INTERCOM PANEL

VSL-123 INTERCOM SLAVE  
INSTALLATION DETAILS

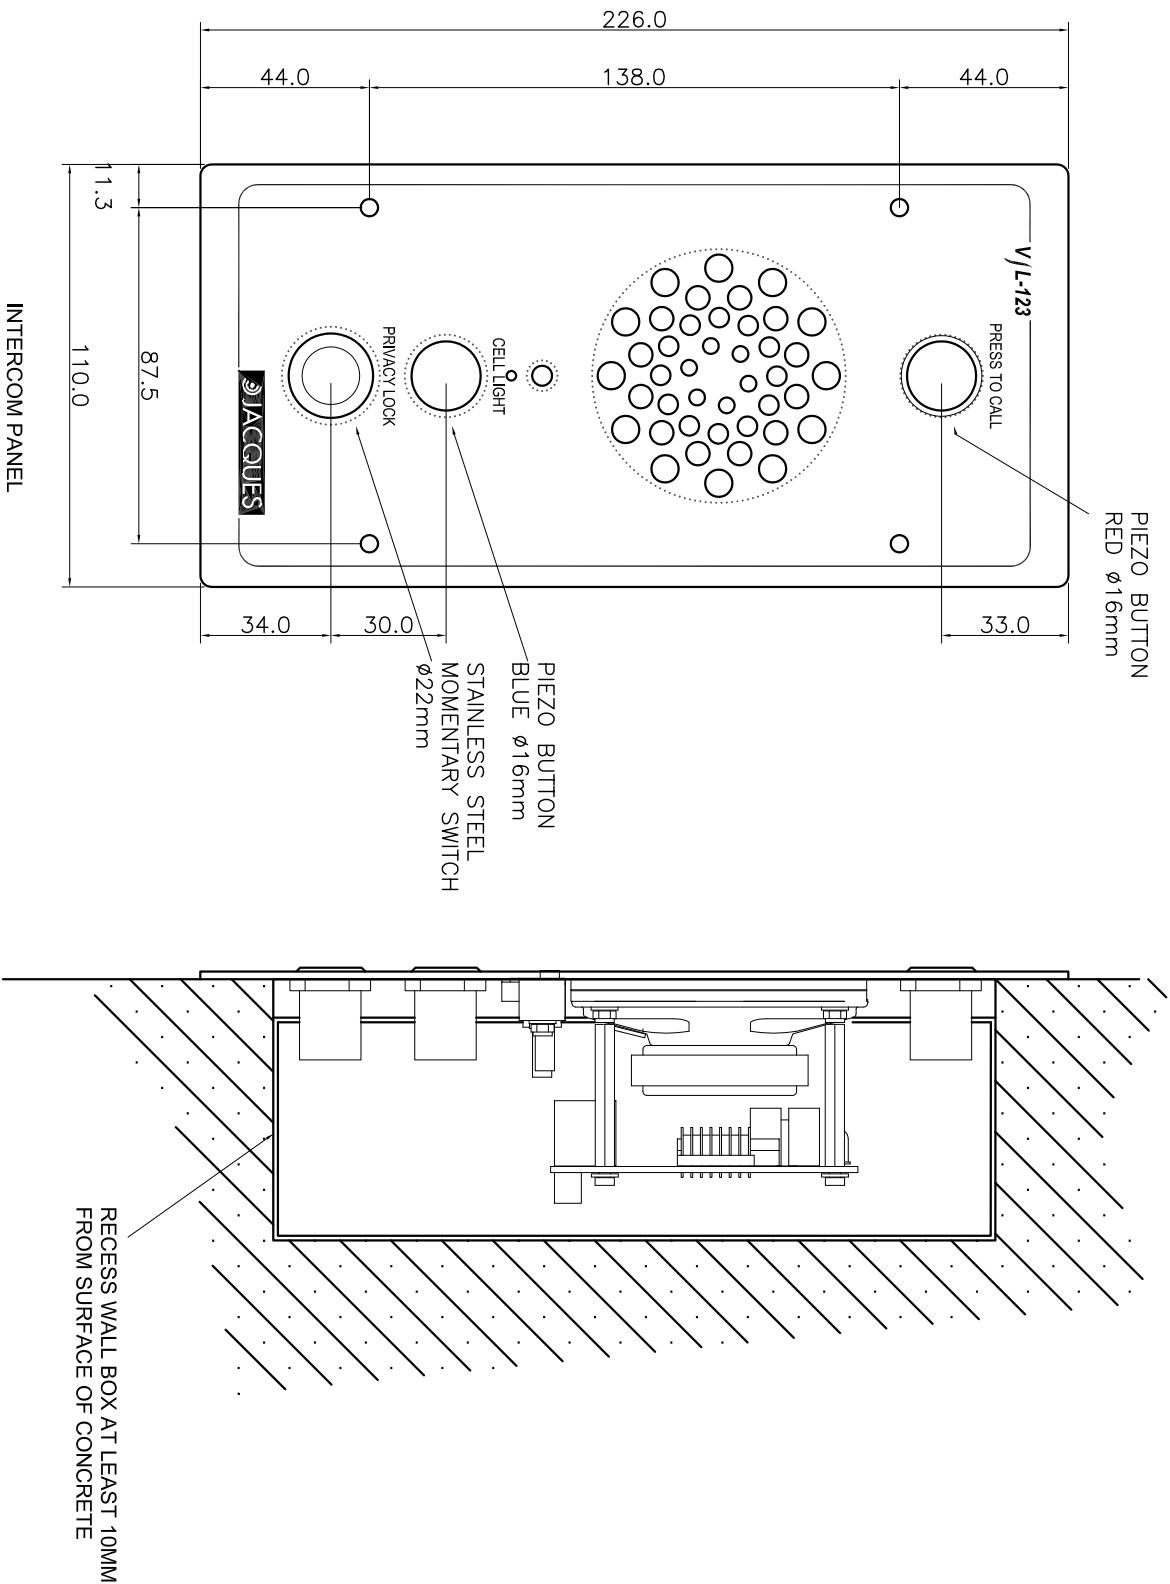
FIRST USE & REVISION NOTES		DATE	INIT
1. WAS VSL-123/B NOW VSL-123. MOUNTING POSITIONS MOVED OUT. PANEL CUT OUT INCL.		01-04-05	JB
2. MOUNTING H.S. WERE 90 NOW 83.5. CUTOUT MOD TO ACCOMOD MOUNTING H.S. COMPARTS LMRD.		06-04-05	JB
2. MOUNTING H.S. WERE 83.5 NOW 87.5. WALL BOX DETAILS ADDED		19-07-05	JB
